Re: Second Amended Subdivision Revisions
Spiller Hill/Gay Brook Lots, Spiller Hill Road
Tax Map 15 Lot 123C
Peter & Donna Marcinuk

These revisions are based on comments received from the Town as well as the Planning Board meeting held on April 12, 2023. The following is our response to the comments sorted by the source of the comments and utilizing the same numbering system for clarity:

Comments from Sebago Technics dated April 6, 2023:

Comments from Fire Inspector dated April 24, 2023:

Scale 1" = 80'
40' Fire Truck

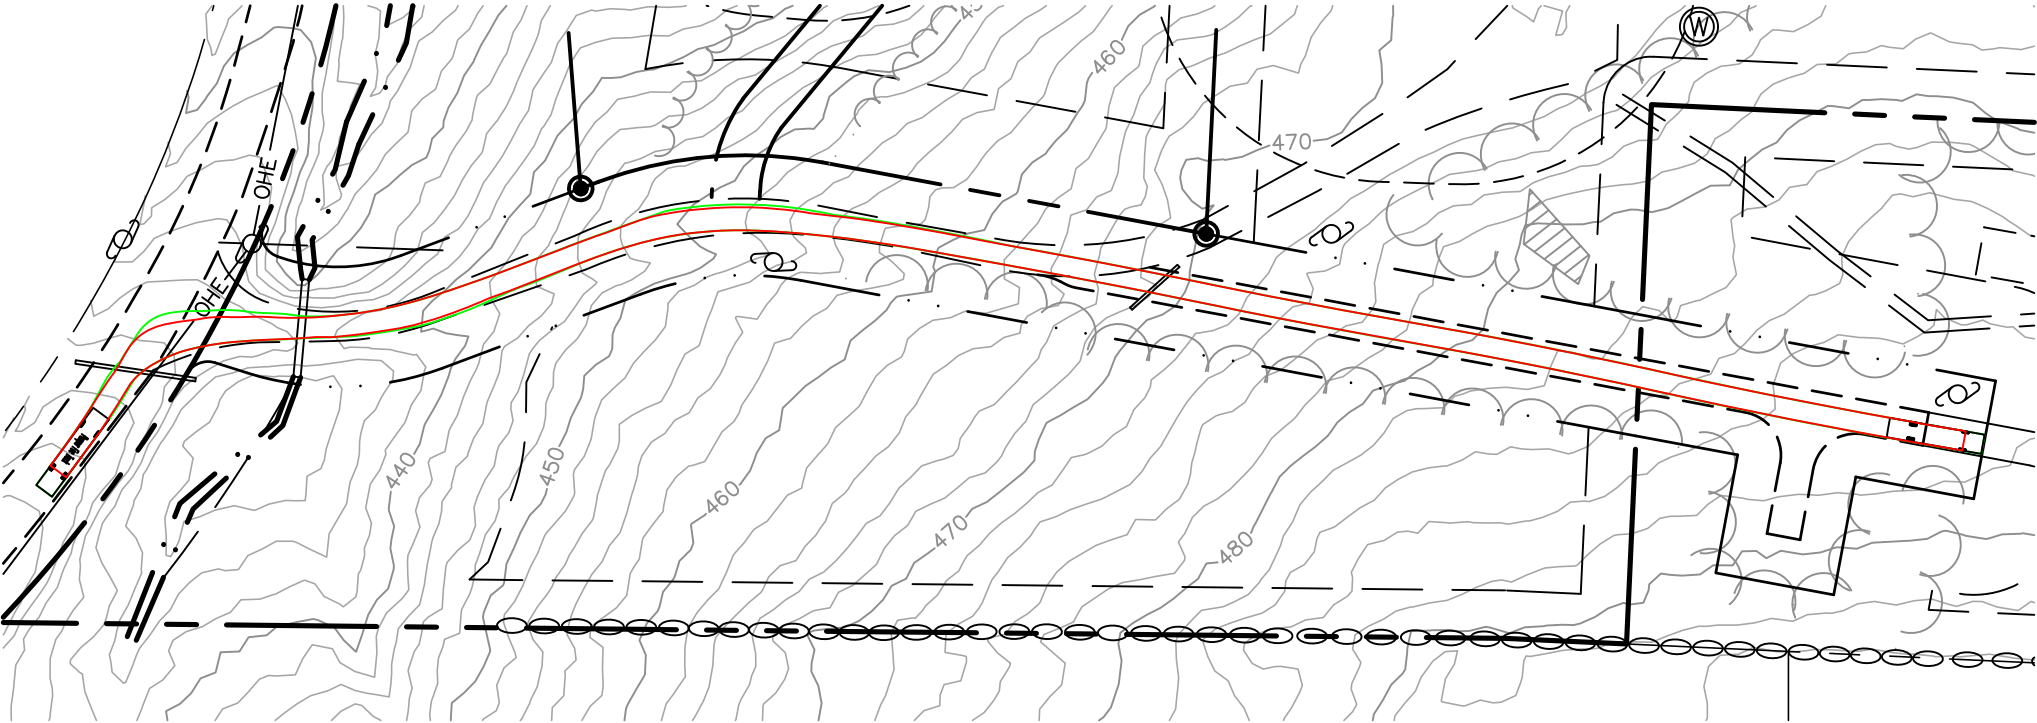
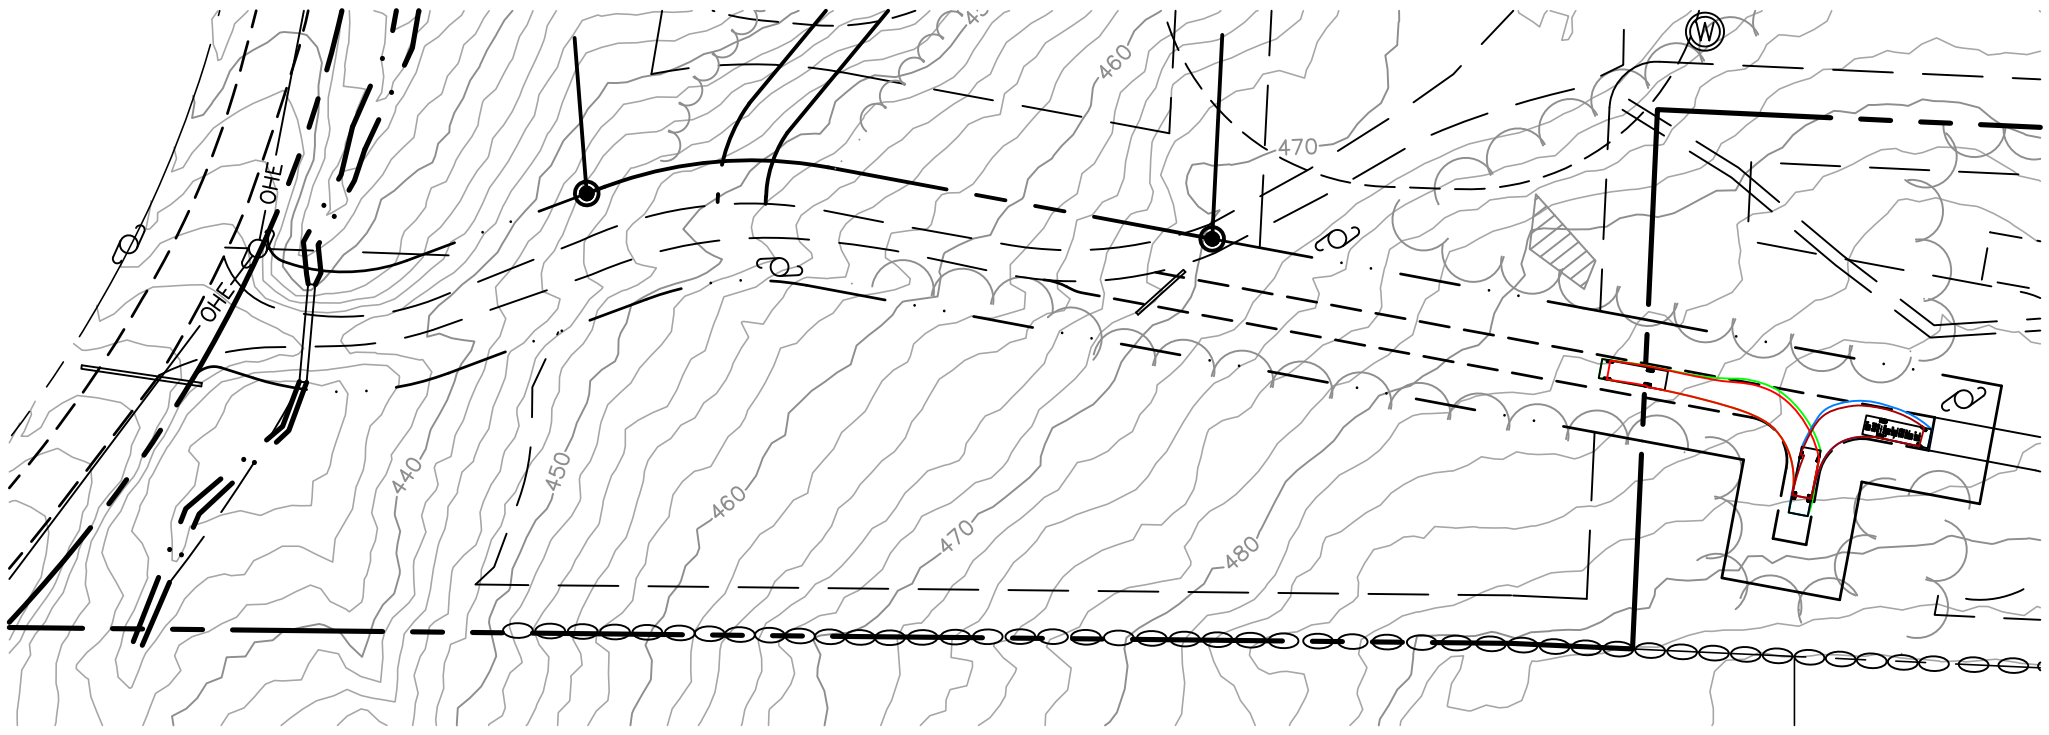
- Please find attached emergency truck turning templates (3) as requested by the Fire Inspector.
- Lidar topo has been added to sheet 1 of the plans as requested (see note #28 for additional information).
- Please find attached a revised roadway maintenance agreement as requested by the board.
